BD71847MWV Functional Errata

The problem described on errata has been solved with new product **BD71847AMWV**. The **BD71847MWV** will be replaced by the **BD71847AMWV**. **BD71847AMWV** has same foot print and functionality with previous **BD71847MWV**.

2. PMIC Hung in OTP Load State

Figure 1: Power State Diagram

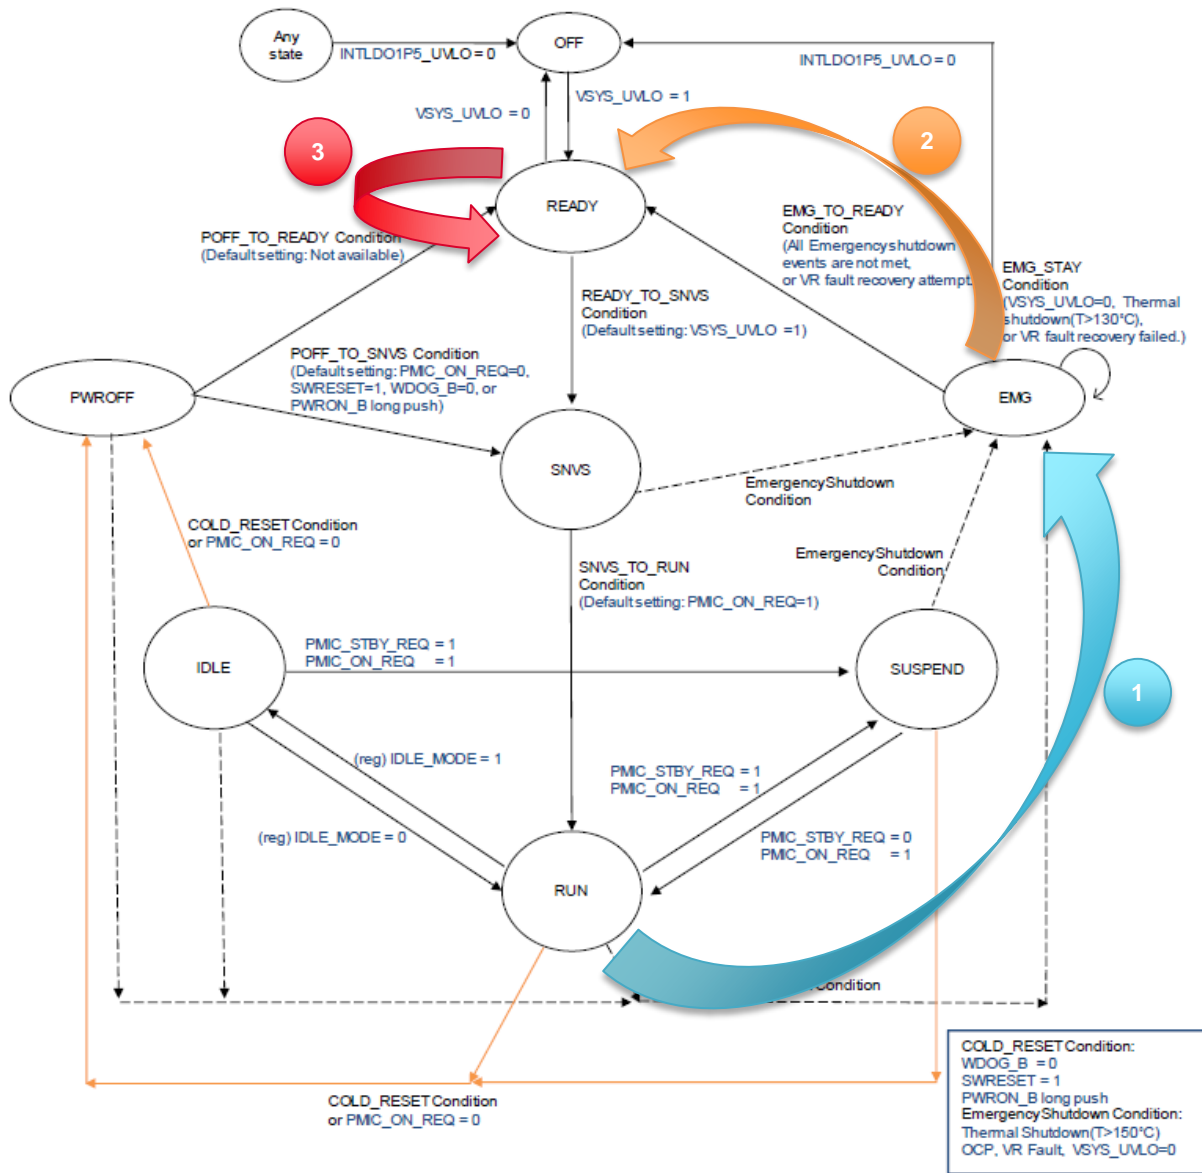
Figure 1 shows the power state transition diagram annotated with arrows showing how the problem could develop and manifest itself.

The test sequence below corresponds to the matching labeled arrows in the diagram.

1. Input supply VSYS is lowered below VSYS_UVLO level (2.7V) => PMIC enters **EMG** state in which all power rails are turned off.
 - VSYS_UVLO is 2.7V (sweeping down) – 3.0V (sweeping up)
2. VSYS is raised above VSYS_UVLO (3.0v) for a ‘short’ time to simulate noise spike => PMIC enters **READY** state in which OTP settings are loaded.

- Here, short means 100 μs – 390 μs. Anything shorter is filtered out by the debounce circuit. Longer duration doesn't cause problem. The reason is OTP loading takes approximately 390 μs.
- 3. If the noise spike lasts less than 390 μs, VSYS drops back to below VSYS_UVLO (2.7V) before OTP loading is completed. PMIC remains in READY state until power is removed, or, more precisely, until VSYS is below 1.35V. At that point, PMIC goes to **OFF** state – the same starting point as first time power-on.

One possible work around is to disable the reloading of OTP while in **READY** state. This would eliminate the cause of deadlock described in 2.3 by reducing the OTP loading time – the time window deadlock may arise – to zero.

To disable OTP loading while in **READY**, OTP must be changed. Specifically, D5 (RELOAD_REG) in PWRCTRL0 register at address 0x03 is to be changed to '0'.

Figure 2: Power State Transition Diagram

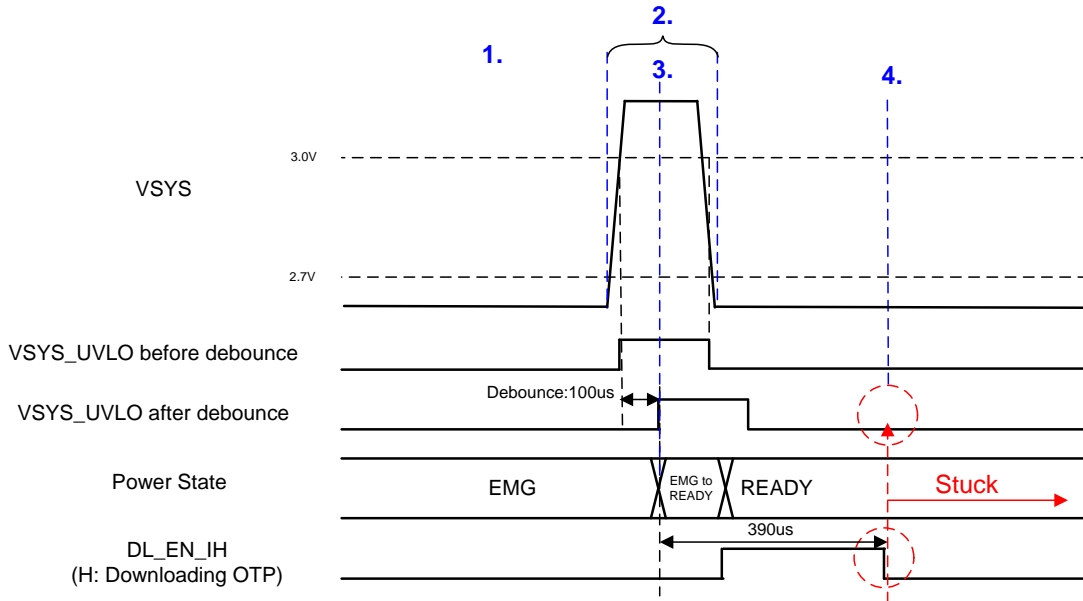
PMIC is stuck in **READY** state because of a deadlock situation between the logic that detects state of VSYS (being below or above VSYS_UVLO) and the power state transition state machine that takes detection result as one of its input.

Internally a pulse is generated upon detection of VSYS_UVLO event. During OTP download while in **READY** state, such pulse is ignored. Since the event is not registered, the power state machine receives no trigger after OTP loading is completed to transition to another state. Hence PMIC remains in **READY**.

A silicon revision will fix the issue; no work around would be needed.
